SERVICE BULLETIN

M-1357A

2014 TWIN-COOLED FILL NECK: PRODUCT PROGRAM 0916

Figure 1. Fill Neck

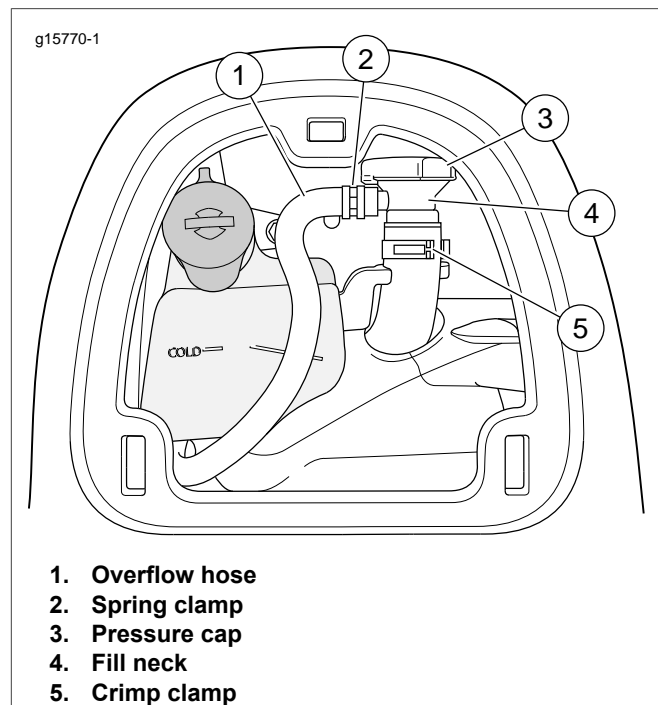
4. See Figure 1. Pull fill neck from retainer on coolant bottle. Remove pressure cap. Retain cap for assembly.
5. Bend the fill hose down and drain coolant into a clean container for reuse. Remove coolant until level is below lower end of fill neck.
6. Remove overflow hose (1) from fill neck.
7. Cut and remove clamp (5). See the service manual.
8. Remove the fill neck from the fill hose.

1. See Figure 1. Place **new** clamp (5) over fill hose.
2. Install **new** fill neck (4) with overflow fitting facing toward the coolant bottle.
3. Crimp the clamp (5). See the service manual.
4. Install the overflow hose (1). Secure with spring clamp (2).
5. Top off coolant in fill neck with coolant removed earlier.

Figure 2. Pressure Cap Installation

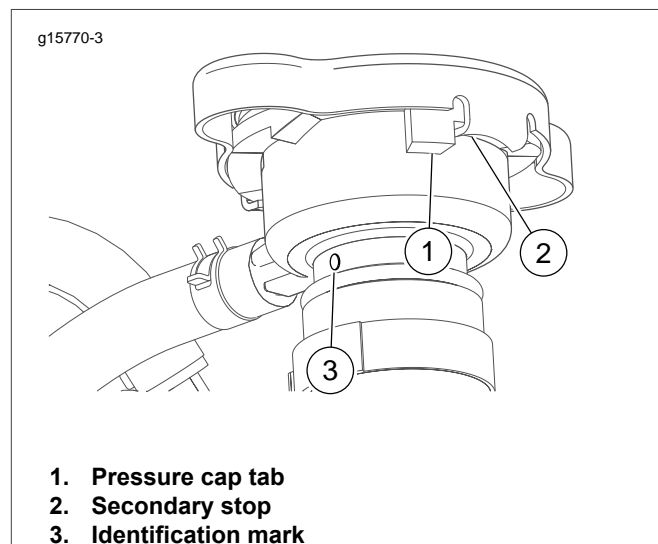
See Figure 2. The **new** fill neck can be identified by an identification mark (3) located just above the hose.

See Figure 2. Verify pressure cap is completely tightened. Tab (2) must contact stop (1) for proper system operation.

See Figure 2. Original Fill Neck (Part No. 26800020) can be easily identified by **not having** the identification mark (3). Remove all inventory of Part No. 26800020 and return following the Additional Credit Procedure below.
